ADDENDUM NO. 2

OWNER: Lower San Joaquin Levee District

PROJECT: FSRP Critical Erosion Repair Project

DWR_NA0010_06_LM3.57L
EROSION SITE 3 - PLAN

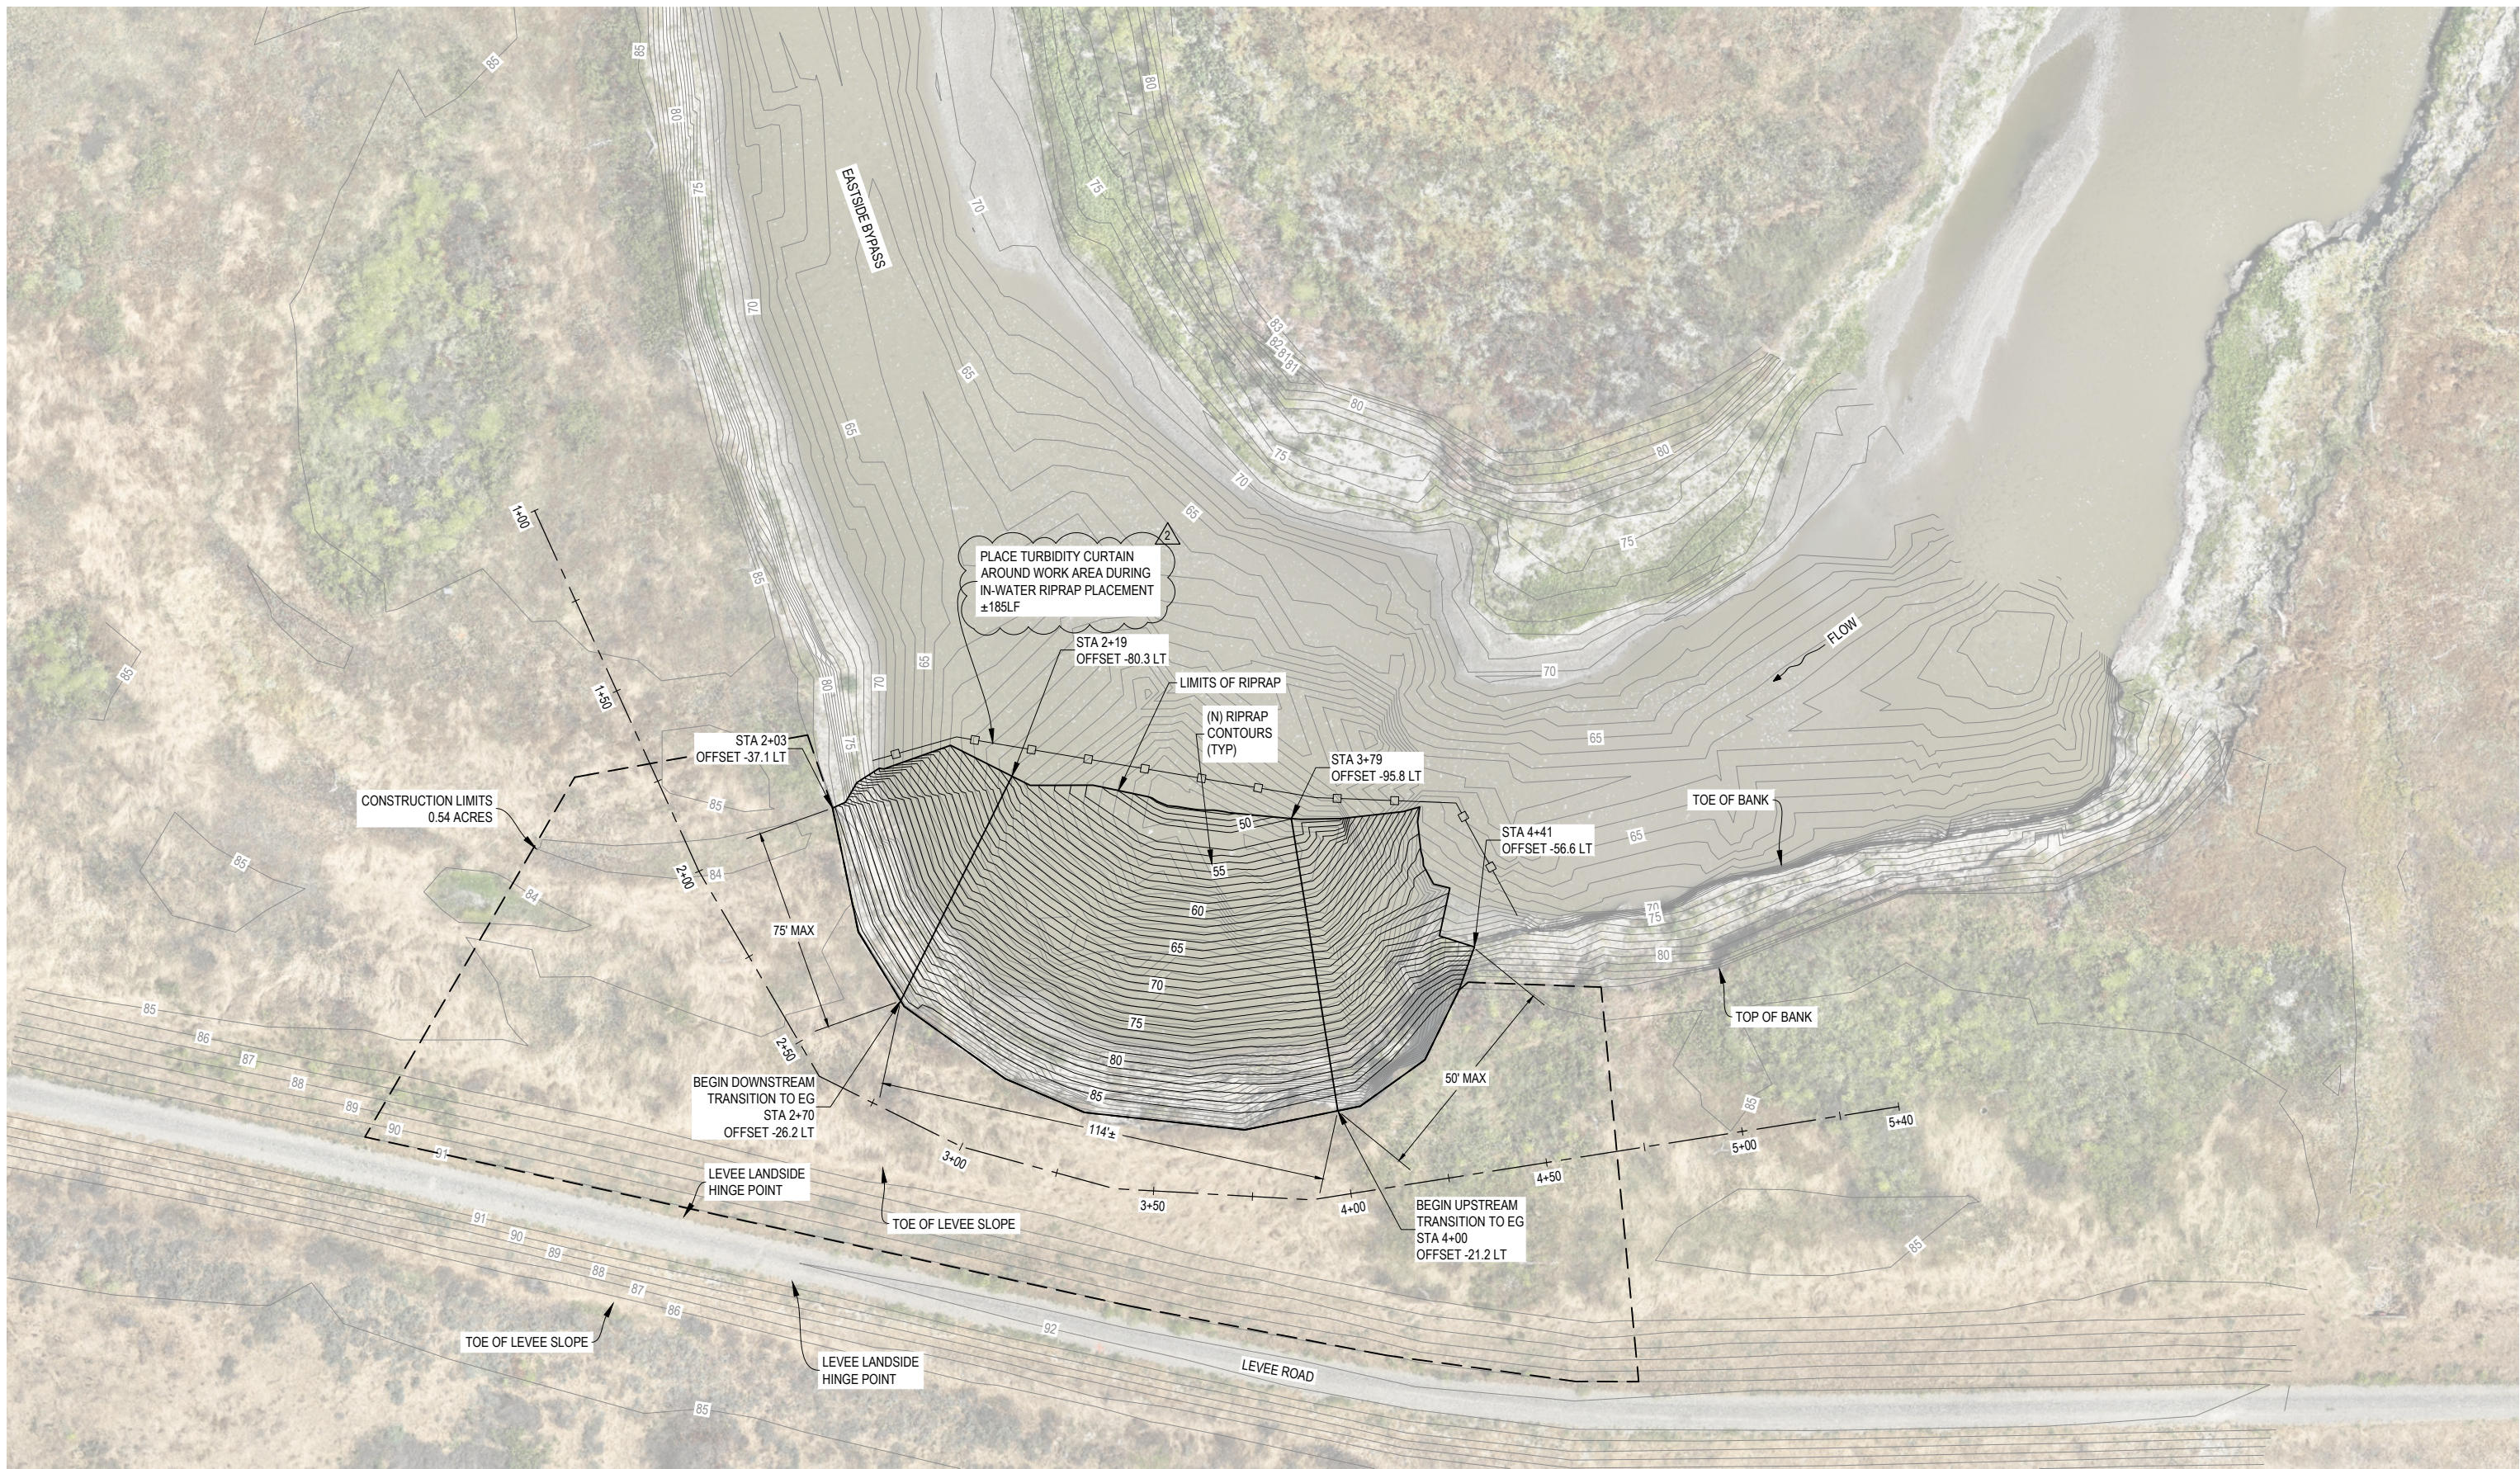
- Q4. It was discussed at the prebid meeting that the current layout showing the turbidity curtain only at the downstream section may change to include**

downstream and upstream due to the minimal flow of water / potential windy conditions. Please advise.

- Q10. Can you also provide further clarification on the approved haul routes / turn around areas? Sites 2 and 3 did not appear to have large turn around areas for heavy trucks. If optional routes are available please provide updated routes.**

- **C-101 – Base Map & Haul Route:** Revised haul routes.
- **CS101 – Erosion Site 1 Plan:** Revised turbidity curtain plan.
- **CS102 – Erosion Site 2 Plan:** Revised turbidity curtain plan.
- **CS103 – Erosion Site 3 Plan:** Revised turbidity curtain plan.

- A4. The Contract Drawings have been revised to show the turbidity curtain layout based on anticipated site conditions. See the revised plan sheets included with this Addendum.

- A10. The Contract Drawings have been revised to identify haul routes. See revised plan sheets included with this Addendum.
